Supplementary Planning Information

HAVANT BOROUGH COUNCIL
DEVELOPMENT MANAGEMENT COMMITTEE
29 August 2019

ADDENDUM

Land at Forty Acres Farm, Havant Road, Havant

Appendix A – Revised sections
with Westway

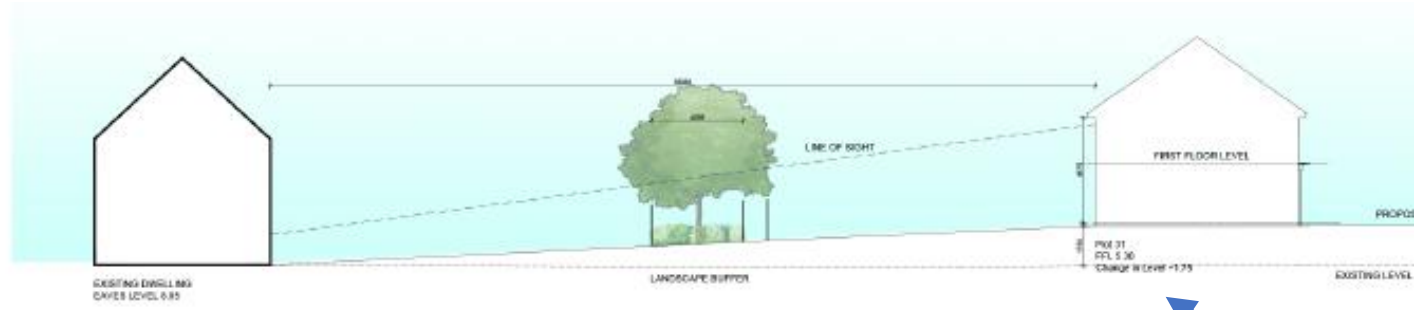
The proposed levels strategy for the site remains, however the proposed sectional drawing with Westways misrepresented the existing ground level of the site. As such, the proposed sectional levels sections had the effect of exaggerating the proposed level changes from the proposed development. Corrected sectional drawings with Westways have now been received, this plan shows that the degree of land raising is to be less than as previously outlined in the officer's report, in relation to levels adjacent to the residential properties in Westways. For clarity paragraphs 7.93, 7.94 and 7.96 have been amended below to reflect these changes. In addition, revised appendices A and B are included in this report, which amend appendices E and F of the main report.
